Re: Interpretation for SE 2008-DR-003, Chevy Chase Bank, 1427, 1433 and 1441 Dolley Madison Blvd., Tax Map 30-2 ((5)) 6, 9 and 10: Architectural Elevations

Re: Request for Interpretation  
SE 2008-DR-003  
Chevy Chase Bank, Dolley Madison Boulevard

1 ELEVATION AT DOLLEY MADISON  
1/4" = 1'-0"

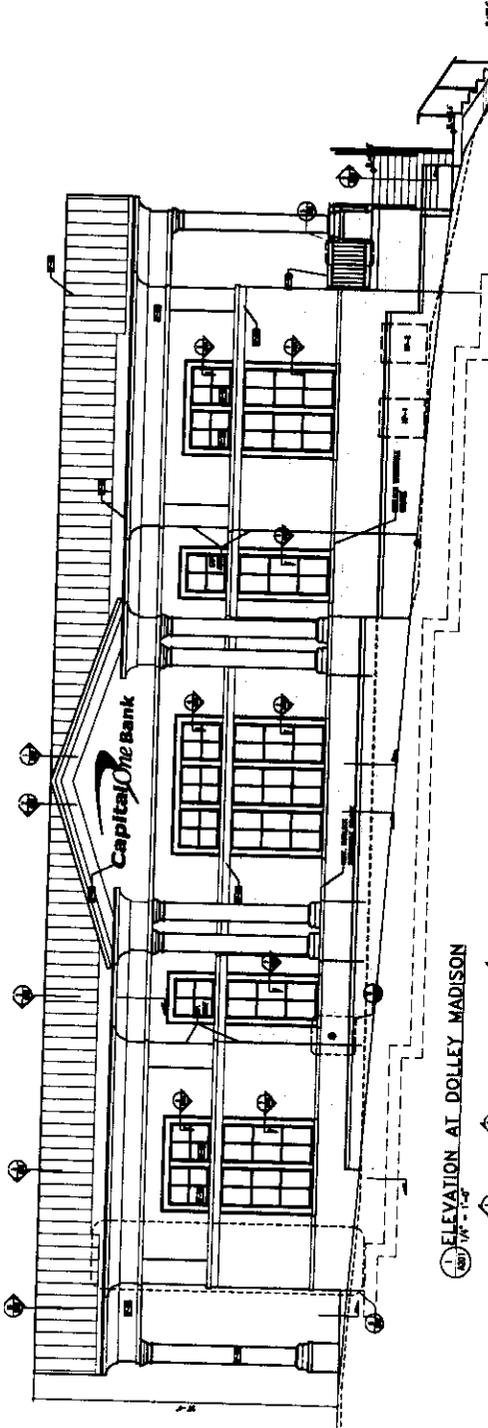
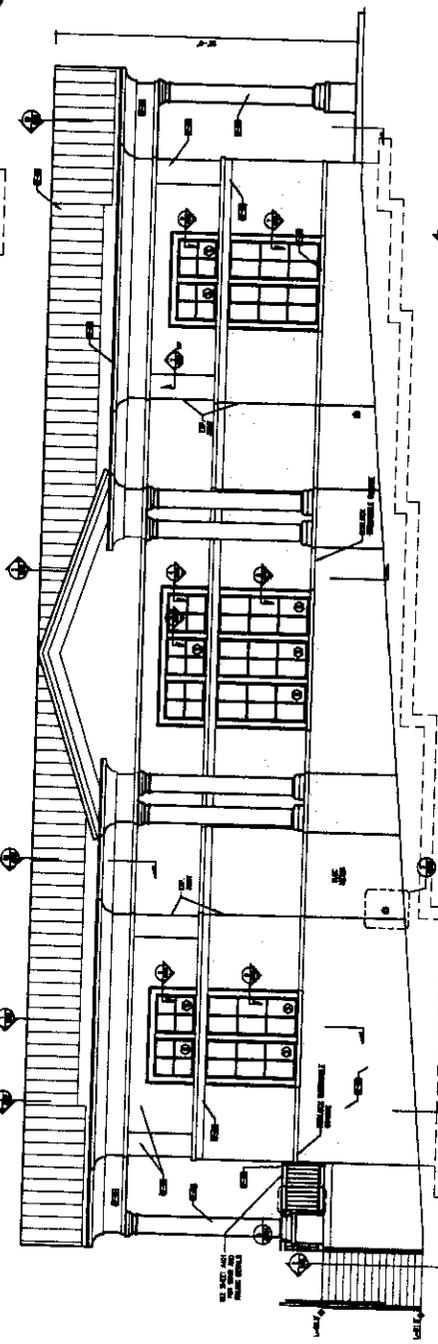
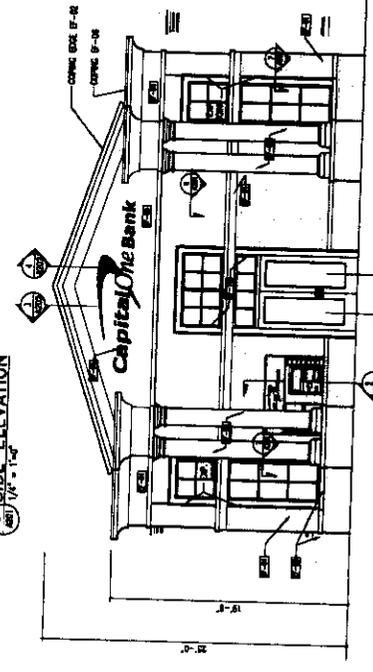
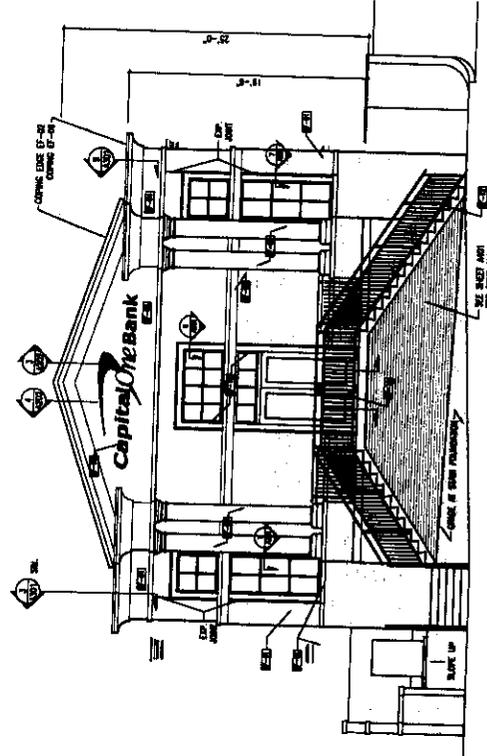
Also enclosed is a copy of the revised architectural elevations of the proposed building now proposed by Capital One Bank. In essence, the revisions consist of the enlargement of the windows and the addition of two portico features to the building. The brick for the proposed building will remain identical to the brick shown on the original architectural elevations, and the building will continue to be comprised of synthetic stucco entablature, and pediments, painted columns and trim. The proposed building reflected in the revised architectural elevations will be the same height, contain the same square footage, and contain the same standing seam metal roof as shown on the original elevations. Likewise, the site layout, landscaping, parking and vehicular access will remain unchanged.

Capital One Bank is also proposing to replace the building-mounted signage for "Chevy Chase Bank" shown on the original architectural elevations with building-mounted signage for "Capital One Bank" as shown on the revised elevations. The proposed revised building-mounted signage will continue to be limited to a maximum of 124 square feet, and no sign will exceed 35 square feet in size as provided in Development Condition #6. The signs will consist of individual letters which are internally illuminated and a red insignia consistent with the registered trademark of Capital One Bank.

As requested, attached are revised elevations showing two second story windows at each entrance to the building.

Based on the above, it is my determination that the proposed architectural elevations for Capital One Bank are in substantial conformance with SE 2008-DR-003. This determination has been made in my capacity as the duly authorized agent of the Zoning Administrator.
